# **WEST FIELD SUBDIVISION**

The plat illustrates the proposed 32.8  $\pm$  acres, 128 lot subdivision which is located on the Northwest corner of Scott Dairy Loop Road West and Westlake Road. The subdivision is served by public water and sanitary sewer.

The purpose of this application is to subdivide a metes and bounds parcel into 128 lots.

## DETAIL SITE PLAN

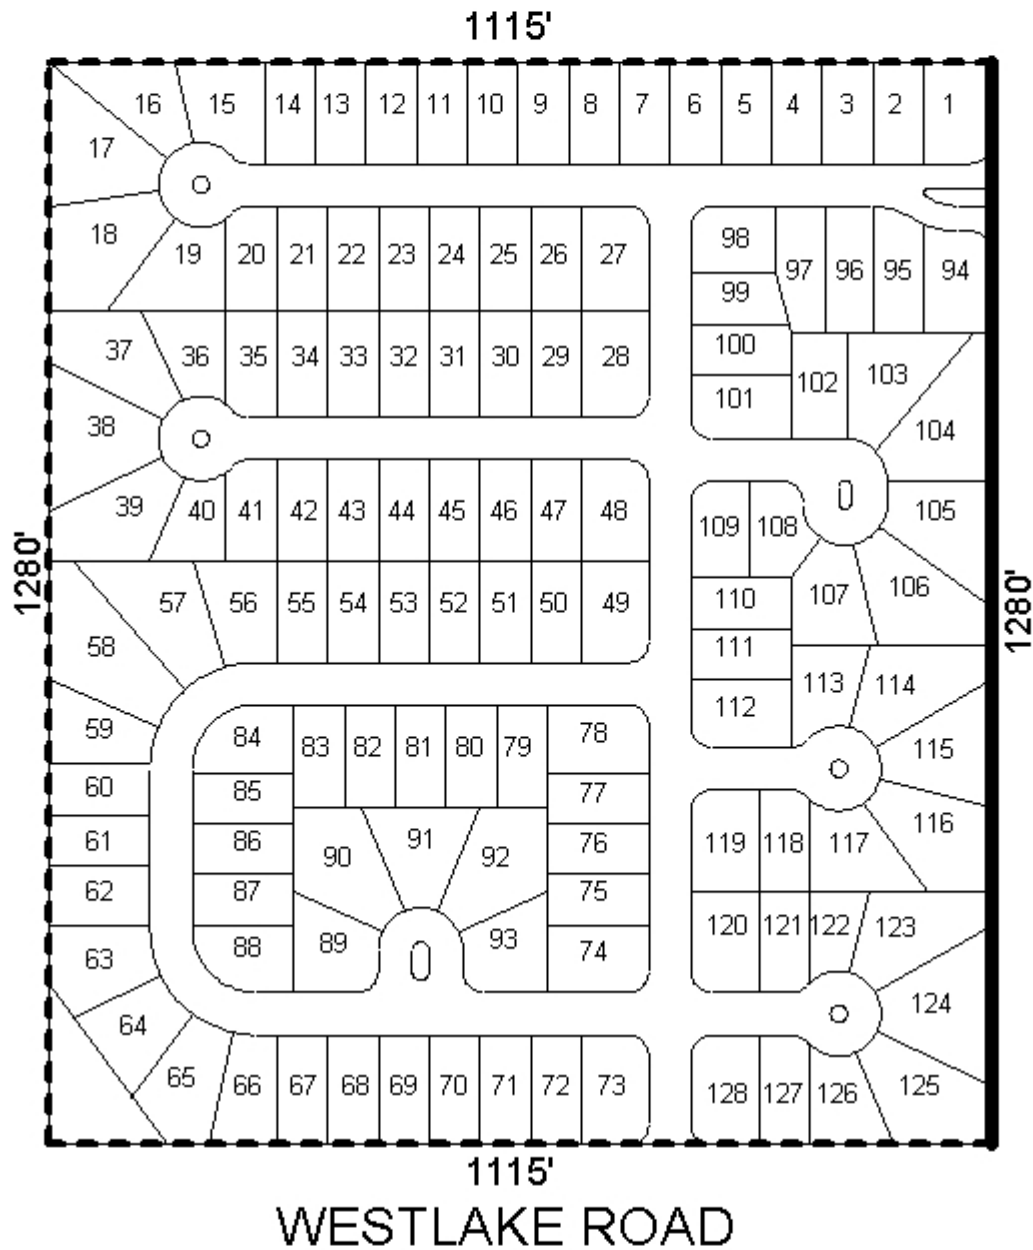
Scott Dairy Loop Road West and Westlake Road, which have existing rights-of-ways of 60-feet, are shown as major streets on the Major Street Plan, and as such require a 100-foot right-of-way. Therefore, the dedication of sufficient right-of-way to provide 50-feet from the centerline should be required.

As proposed, Lots 1, 65-73, 94, 104-106, 114-116, 123-125, and 126-128 would have double frontage along major streets and new streets. In order to provide proper access management along the Major Streets, the placement of a note on the final plat stating the Lots 1, 94, 104-106, 114-116, 123-125 are denied direct access to Scott Dairy Loop Road West, and Lots 65-73, 126-128 are denied direct access Westlake Road should be required.

Section V.B.1 states that when a proposed subdivision is adjacent to large unsubdivided land, a street stub should be provided to allow for convenient circulation; therefore, the provision of a street stub to the west, should be required.

As shown on the site plan, there is an area at the southwest corner of the subdivision, to the rear of Lots 63-65, that is not labeled as common area or detention. Therefore, this area should be labeled and a note placed on the final plat stating that the maintenance thereof is the responsibility of the property owners.

The 25-foot minimum building setback line is not shown but would be required on the final plat.

The plat meets the minimum requirements of the Subdivision Regulations and is recommended for Tentative Approval subject to the following conditions: 1) the dedication of sufficient right-of-way to provide 50-feet from the centerline of Scott Dairy Loop Road West and Westlake Road; 2) the placement of a note on the final plat stating the Lots 1, 94, 104-106, 114-116, 123-125 are denied direct access to Scott Dairy Loop Road West, and Lots 65-73, 126-128 are denied direct access Westlake Road; 3) the provision of a street stub to the west; 4) the area in the southwest corner of the subdivision, to the rear of Lots 63-65 to be labeled as common area and/or detention and a note placed on the final plat stating that the maintenance thereof is the responsibility of the property owners; 5) the placement of the 25-foot minimum building setback line on the final plat; and 6) the placement of a note on the final plat stating any lots which are developed commercially, and adjoin residentially developed property, must provide a buffer, in compliance with Section V.A.7. of the Subdivision Regulations.
